## SAFETY RECALL 0806 – M2 CYCLONE FRONT BRAKE LINE WIRE GUIDE

Figure 1. Removing Wire Guide

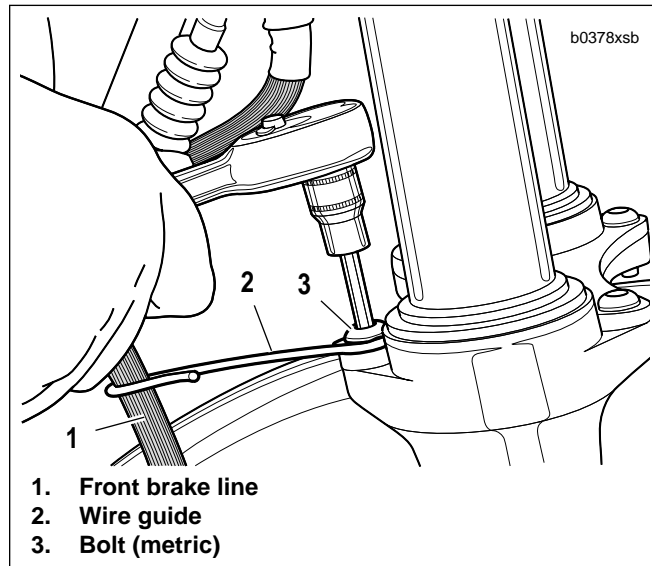
Buell has learned that the front brake line guide could cause the front brake line hose to kink during front brake operation. This could impede return brake fluid flow and prohibit the immediate release of the front brake caliper pistons. This could occur without prior warning. Rear brake performance is not affected.

As a precautionary measure, Buell Motorcycle Company elected to initiate a voluntary recall in the interest of motor vehicle safety. The condition will be remedied by removing the front brake line wire guide on all potentially affected vehicles.

- See Figure 1. If vehicle has a wire guide (2) installed around the front brake line (1), remove bolt (3) (metric).
- Remove end of wire guide from brake line. Cut wire guide into two pieces and discard.
- Apply two drops of LOCTITE THREADLOCKER 242 (blue) to threads of bolt (3) (metric). Install bolt and tighten to 10-12 ft-lbs (13.6-16.3 Nm).
